DATE: February 17, 2026
TO: ALL CONTRACTORS
FROM: DUSTINE TILL
PROJECT: ROSCOE ROAD WATER TREATMENT PLANT
ORANGE BEACH WATER AUTHORITY
GMC PROJECT NO. CMOB230049
RE: ADDENDUM #3

ADDENDUM NUMBER 3

ROSCOE ROAD WATER TREATMENT PLANT

GMC PROJECT NO. CMOB230049

A8 ENLARGED LAB PLAN
SCALE: 3/8" = 1'-0"

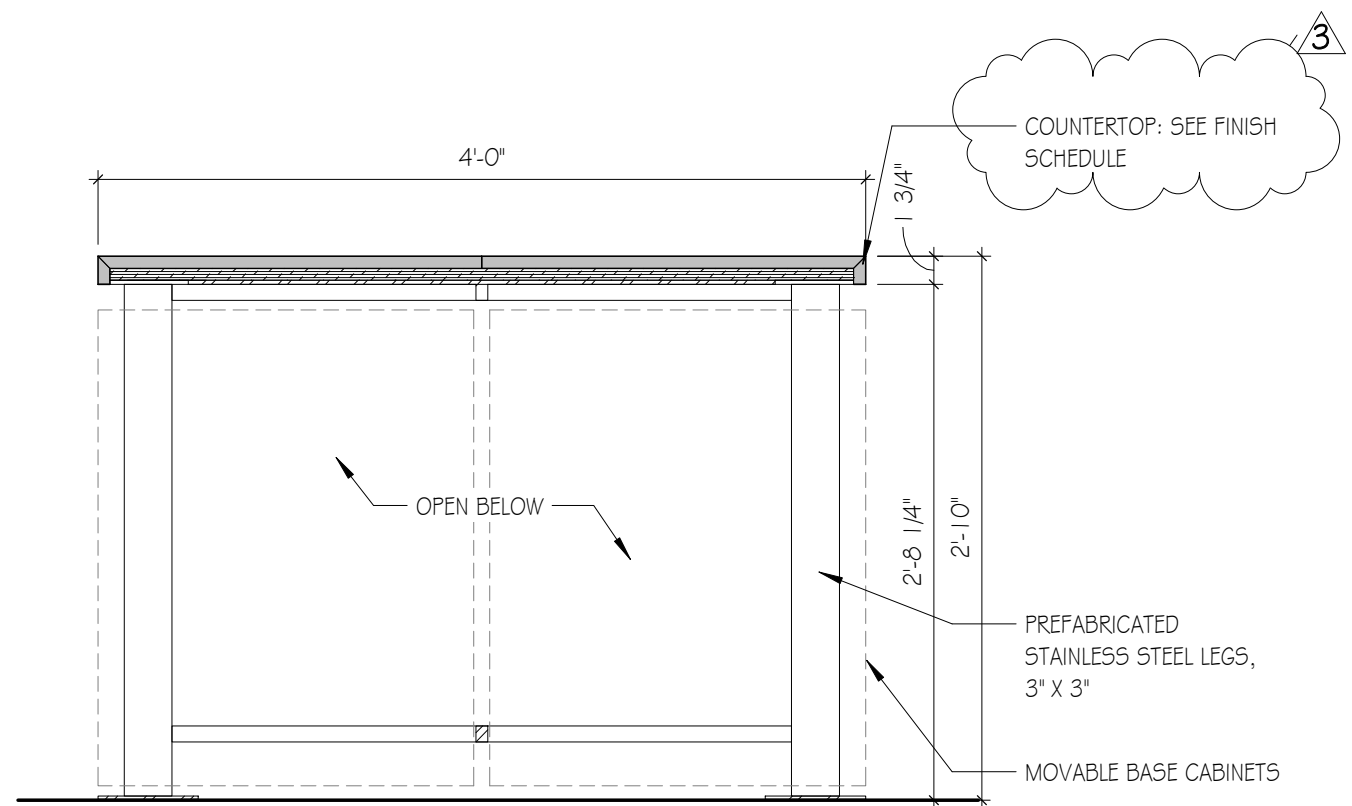
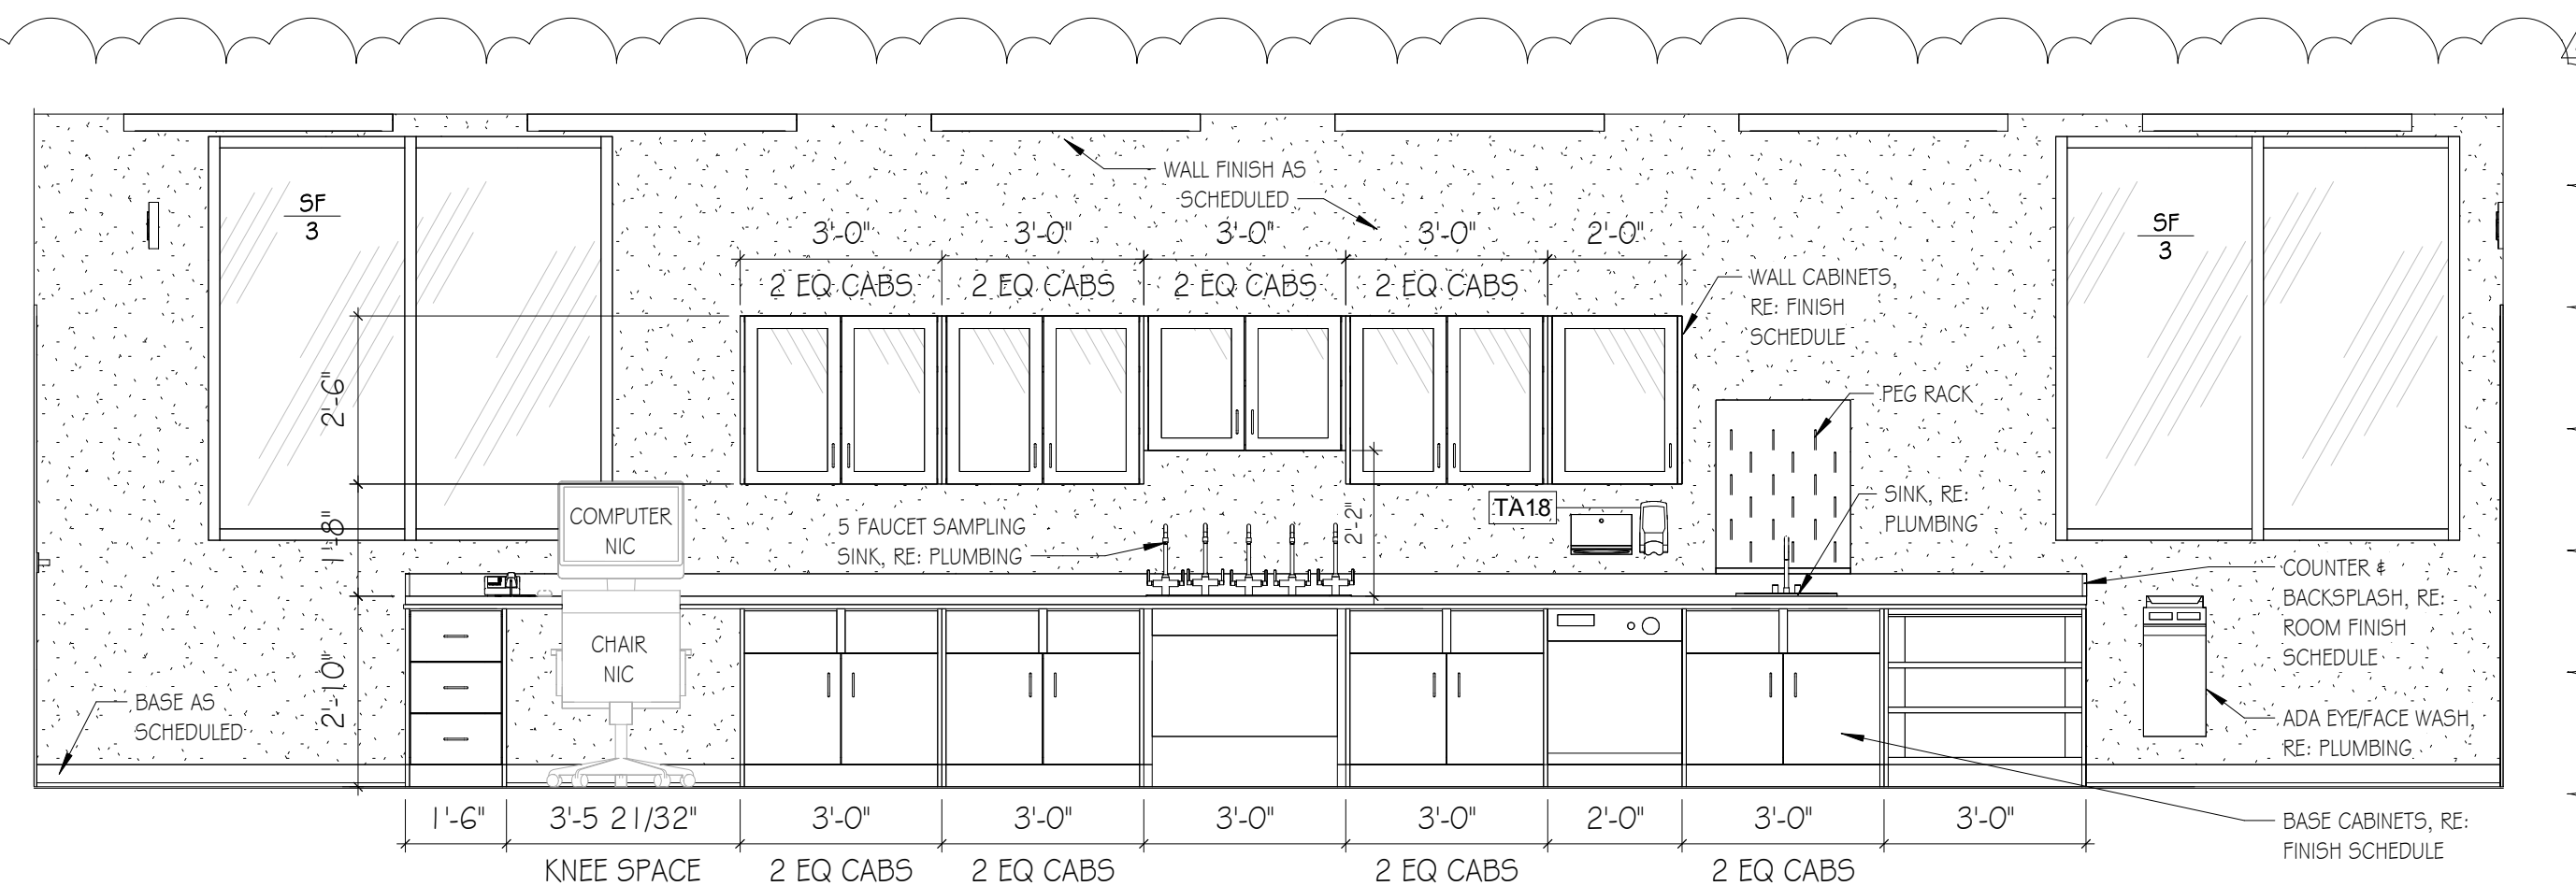
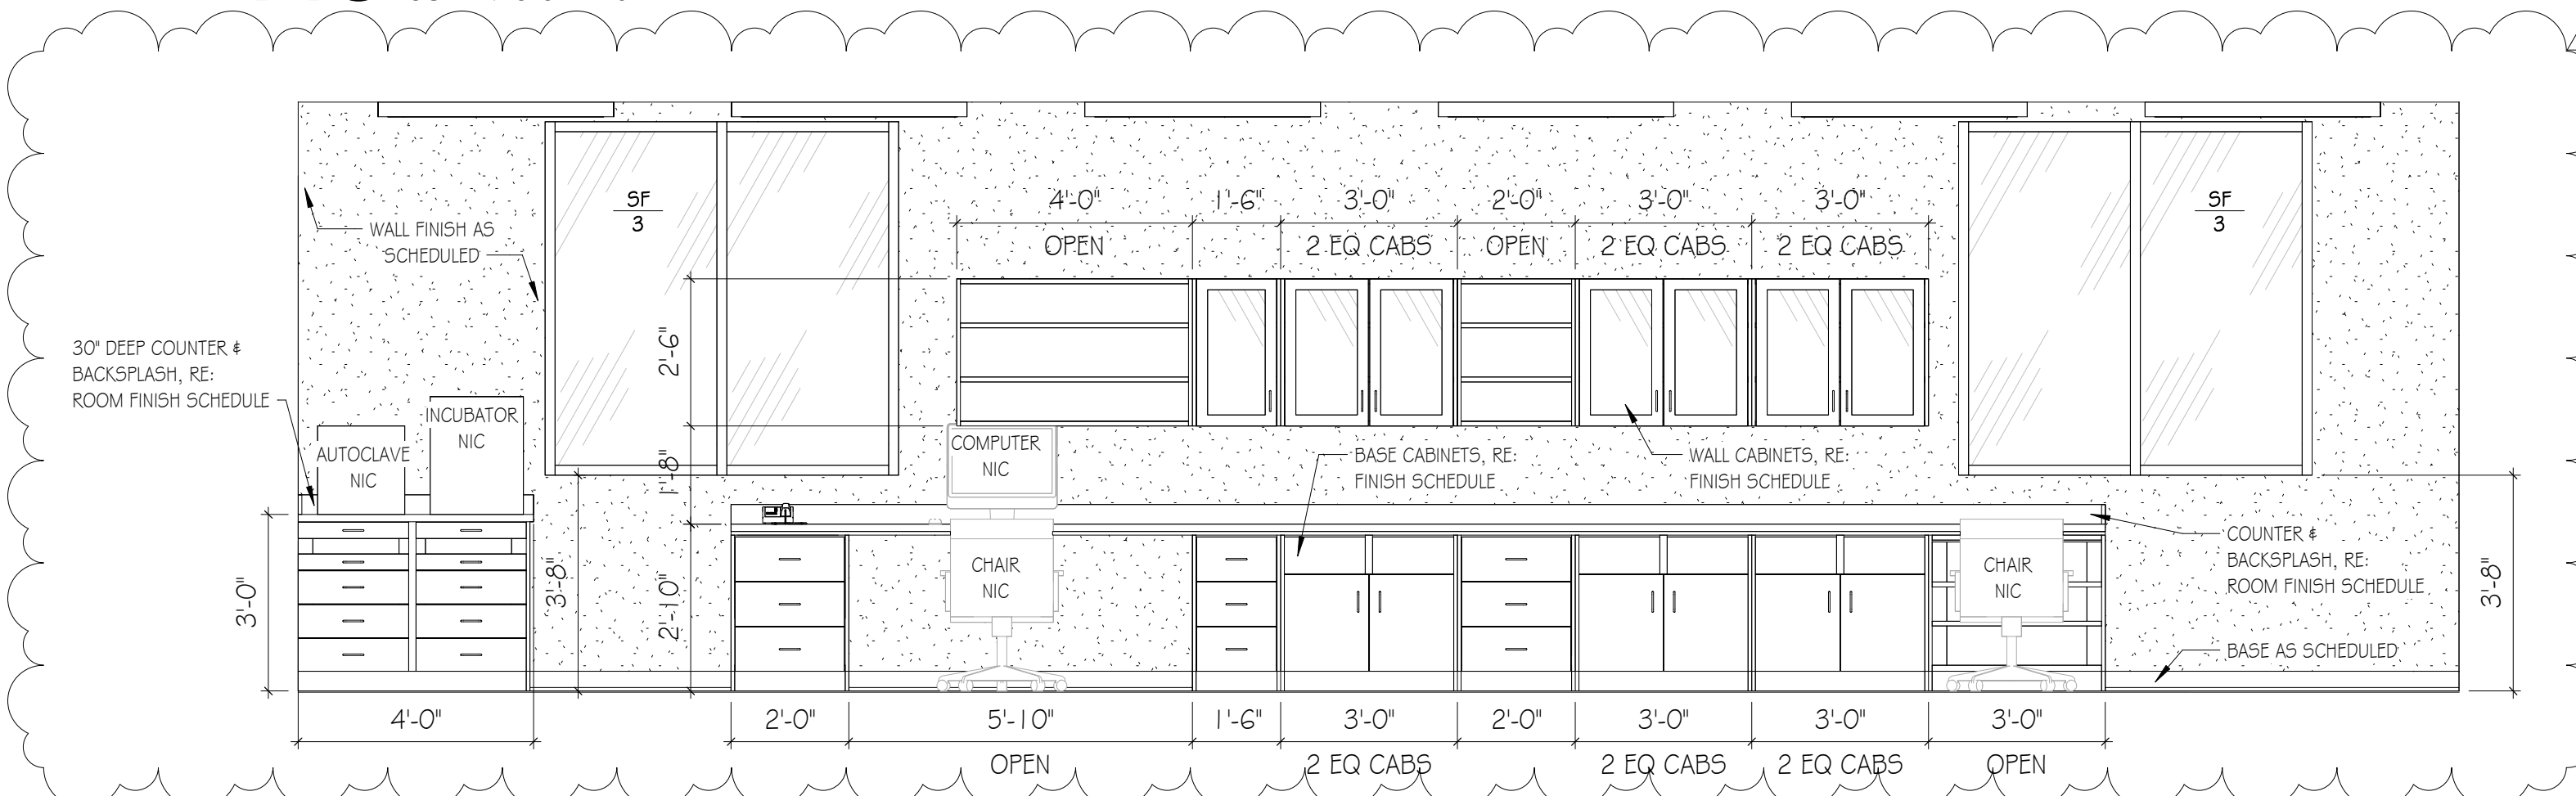
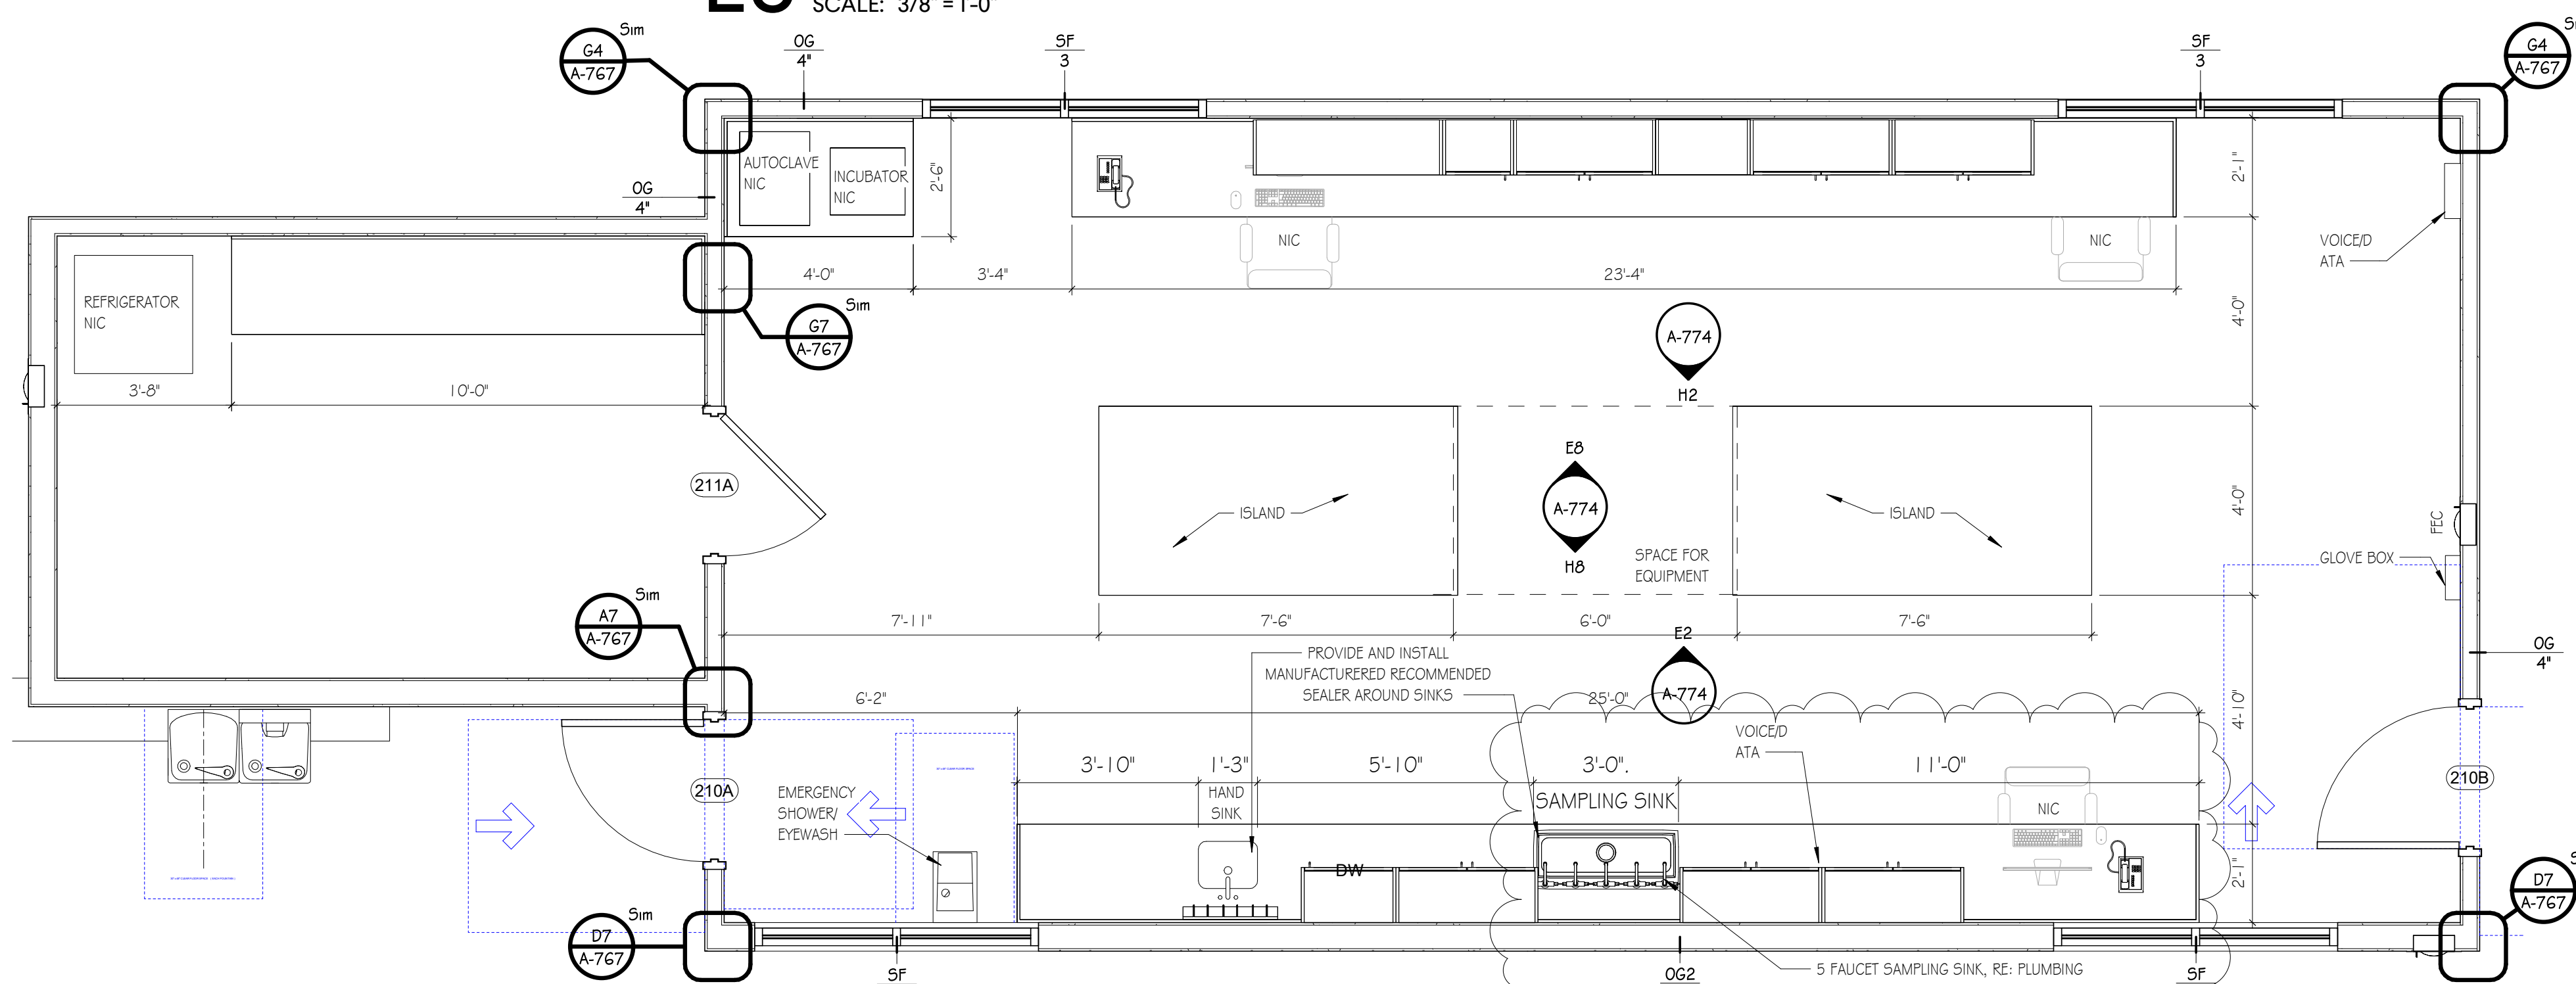
- 5.54 **Question: Drawing A-774 and details on A-775 show the lab casework as plastic laminate material. We assume this is incorrect and that A-781 "Finish Schedule" takes precedence where it calls for Lab Casework to be per spec (12 35 50 and 12 35 53.13), which is steel casework and epoxy tops. Please confirm.**

Answer: Lab casework should be steel casework and epoxy countertop per specs. The millwork sections have been removed because these will not be millwork, but will be lab casework. See revised Sheet A-774 where revisions are clouded.

Answer: See the revised valve schedule for clarification on the small diameter check valve types.
- 5.67 **Question: The Lab has only a 3 faucet sample sink noted on sheet A-774 but 5 sample lines are to be routed to the Lab. Should this sink be modified to accept 5 sample lines?**

Answer: Yes, the sink shall have 5 sample faucets. See revised Drawing A-774.
- 5.68 **Question: Please confirm 3000 psi concrete is acceptable for all footings.**
